ADDENDUM NO. 2

**CONTRACT DOCUMENTS FOR THE CONSTRUCTION OF THE
TURLOCK REGIONAL WATER QUALITY CONTROL FACILITY
SECONDARY CLARIFIER NO. 5 AND DENITRIFICATION PROJECT**

CITY PROJECT NO. 15-39C

May 24, 2017

TYPICAL DETAIL C311 - STORMWATER DETENTION BASIN EXCAVATION AND
BACKFILL

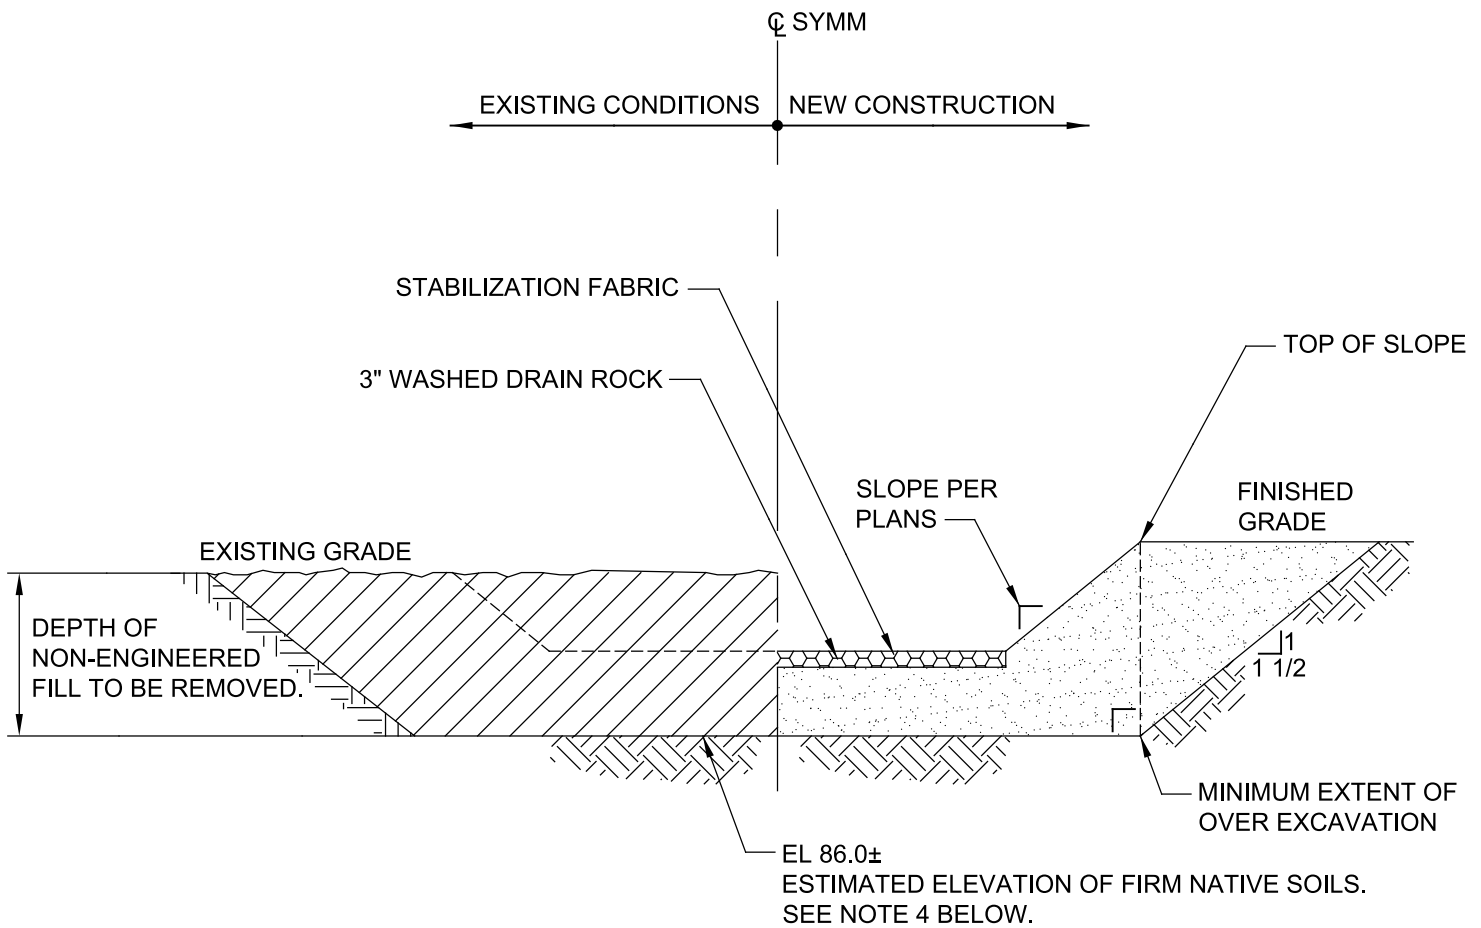
A. Add Typical Detail C311, attached.

B. Delete Key Note 6 and replace with the following: "*PRIOR TO GRADING, OVER-EXCAVATE ALL LANDFILL MATERIAL FOR THE STORMWATER DETENTION BASIN TO DEPTH OF FIRM NATIVE SOILS AND BACKFILL IN ACCORDANCE WITH DETAIL C311/TYP.*"

1.  AREA OF REQUIRED REMOVAL.
2.  AREA OF COMPACTED FILL. PROVIDE SUITABLE NATIVE OR SELECT IMPORTED MATERIALS AS SPECIFIED.
3.  3" WASHED DRAIN ROCK OVER STABILIZATION FABRIC
4. ESTIMATED ELEVATION OF FIRM NATIVE SOILS IS FOR BID PURPOSES ONLY. ACTUAL ELEVATION OF BOTTOM OF OVER-EXCAVATION MAY VARY BASED ON SITE CONDITIONS. OVER-EXCAVATION SHALL EXTEND TO COMPETENT SOILS AS DETERMINED BY THE ENGINEER. ENGINEER SHALL OBSERVE SUBGRADE CONDITIONS BEFORE FILL OR BACKFILL IS PLACED.
5. NON-ENGINEERED FILL IS DEBRIS OF UNKNOWN MAKE-UP INCLUDING WOOD, PLASTIC, CANS, GLASS AND PAPER.

DRAWING NO. 03S02 - RAS PUMP STATION NO. 2 SECTIONS

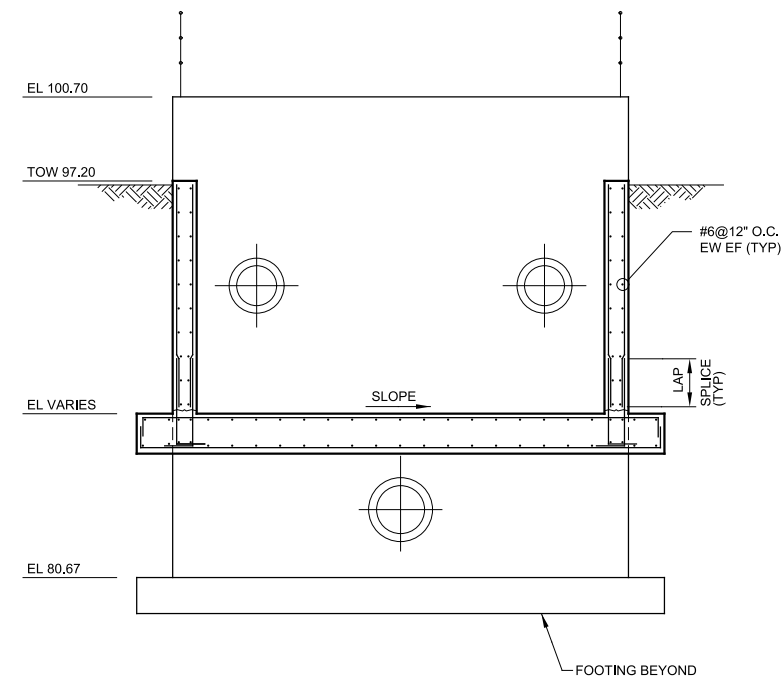
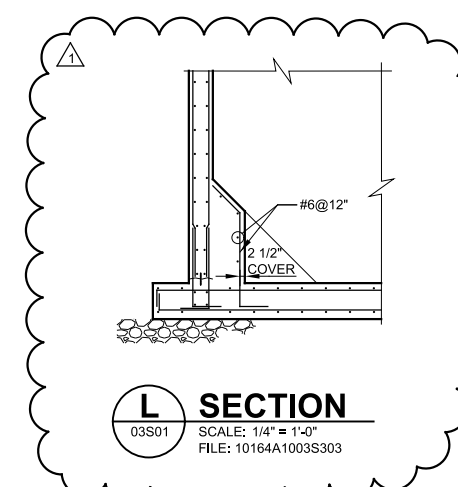
B. SECTION C:

1. Add Key Note 3 callout adjacent to callout *"CLSM BACKFILL UNDER FLOW METER PIT"*. Key Note 3 shall read: *"BACKFILL WITH CLSM FROM BOTTOM OF 12" ABC TO UNDISTURBED FIRM NATIVE SOILS."*

- 1 WALL VERTICAL REINFORCEMENT TO TERMINATE 3" FROM TOP OF WALL TO AVOID INTERFERENCE WITH ACCESS HATCH FRAME. CONTINUE WALL HORIZONTAL REINFORCEMENT TO TOP OF WALL AND PROVIDE A MINIMUM 2" COVER.
- 2 OVER EXCAVATE TO REMOVE ALL LANDFILL MATERIAL UNDER AND SURROUNDING PROPOSED FOUNDATION WITHIN 5'-0" ALL AROUND. BACKFILL UNDER STRUCTURE WITH ENGINEERED FILL. REFER TO DETAIL C310/TYP FOR SUBGRADE PREPARATION REQUIREMENTS.
